**BOARD OF ZONING ADJUSTMENT
STAFF REPORT****Date: August 5, 2013****CASE NUMBER**

5843

Awadhesh K. Gupta

7155 Airport Boulevard
(South side of Airport Boulevard, 108'± East of Park
Avenue South)

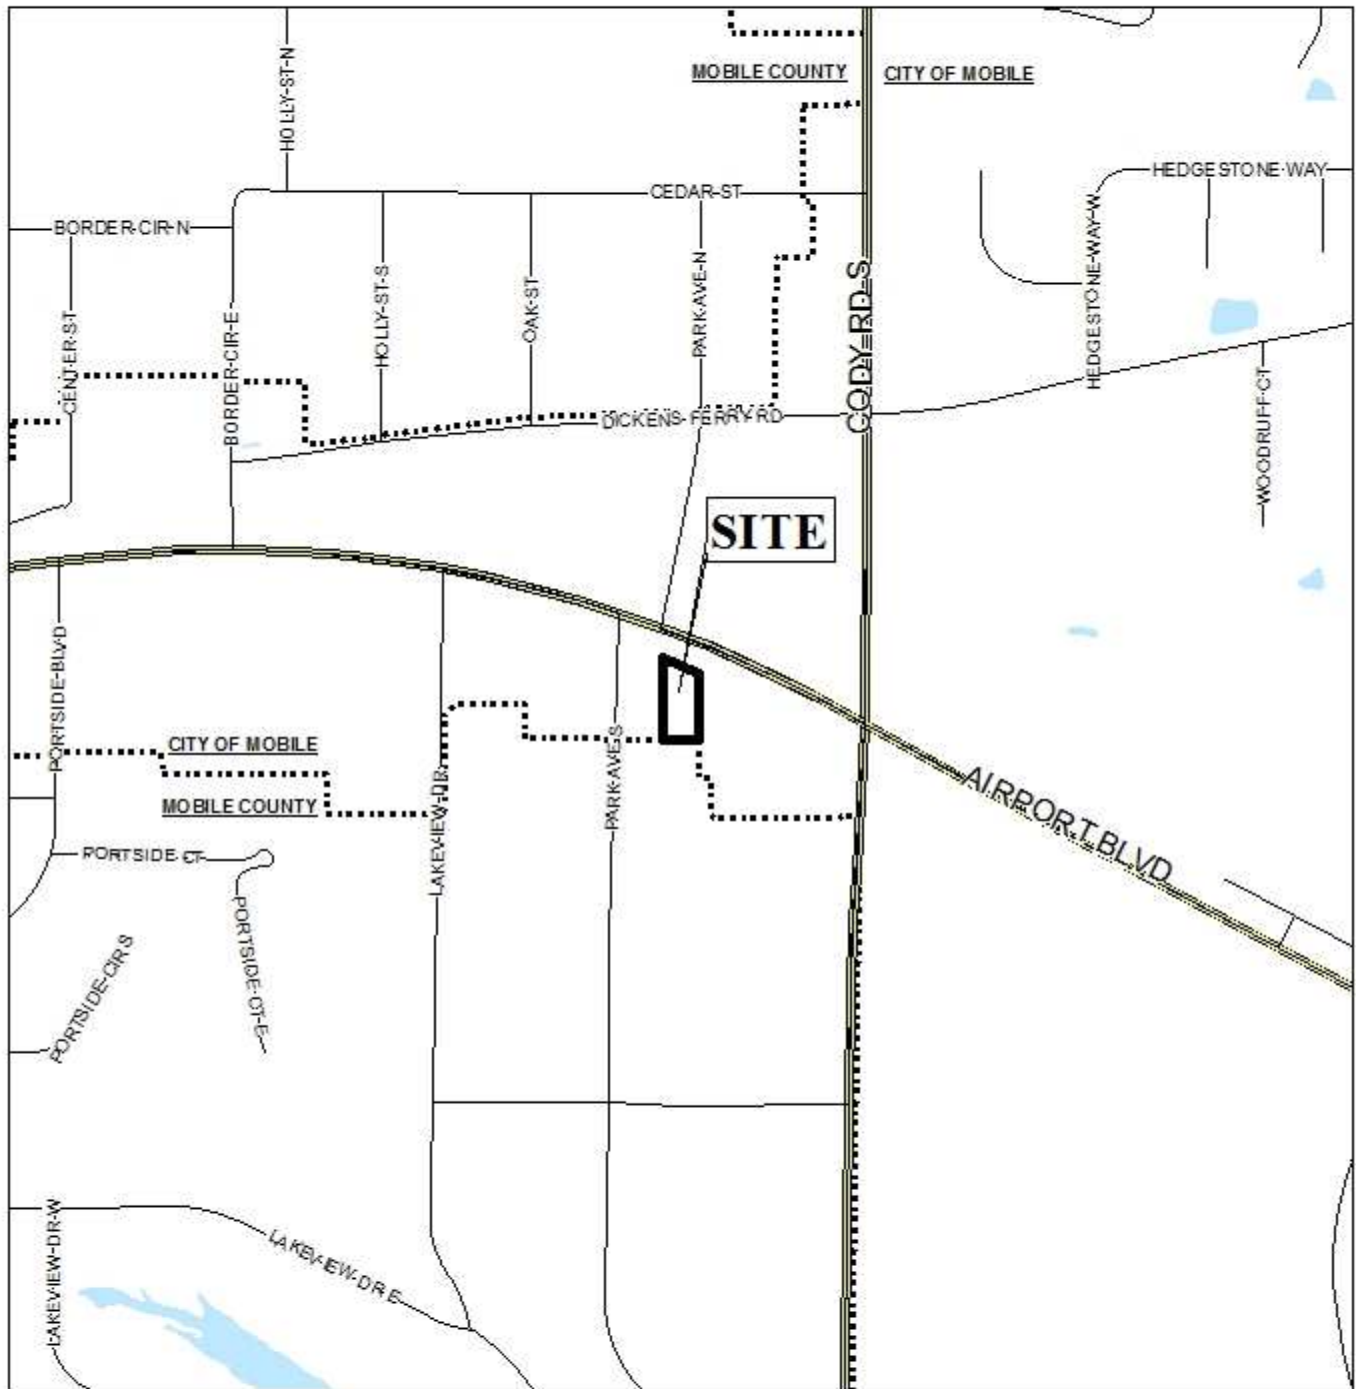
As the site has more than 6,179 square feet of front landscaping area and is required to have 1,366 square feet of such, there exists an excess of 4,813 square feet of front landscaping area, mainly West of the existing parking area. This would provide sufficient room to provide at least the total number of fifteen parking spaces required for the building, and possibly more. The applicant states that only about 300 square feet of the building will be used for the proposed auto sales business which would require one parking space. However, with the revision of the site plan to provide at least two more compliant parking spaces, the site can be made compliant with the current parking requirements.

With regard to the frontage tree planting requirements, there are currently no frontage trees but the site has sufficient trees to meet the perimeter and parking tree requirements. Urban Forestry has determined that the site has sufficient area to provide the required three Live Oak trees within the front 25' along the West side near the billboard sign.

With regard to the Access Variance, a reconfiguration of the parking area to move the handicap parking space to be beside the small front asphalt walk would provide space for a 12' wide one-way drive to an expanded parking area along the West boundary. The relocation of the Northern-most parking space just South of the existing freestanding sign on the two support columns to an expanded West parking area would allow for a compliant 12' wide one-way drive from the expanded parking area thus negating the need for the Access Variance.

Other aspects of the site plan not in compliance with current standards are the substandard 13' wide entrance curb cut, the lack of parking area bumper stops, the non-specification of the rear fence adjoining adjacent residential property to the South, and no provision of a dumpster and enclosure, or a note specifying none will be utilized and that refuse collection will be curbside or via private collection. As these aspects were not requested relief via additional variance requests, they should be corrected prior to further commercial use of the property. Sufficient area exists along the Airport Boulevard right-of-way to provide a compliant 24' wide, two-way curb cut.

Based on the preceding, this application is recommended for denial.
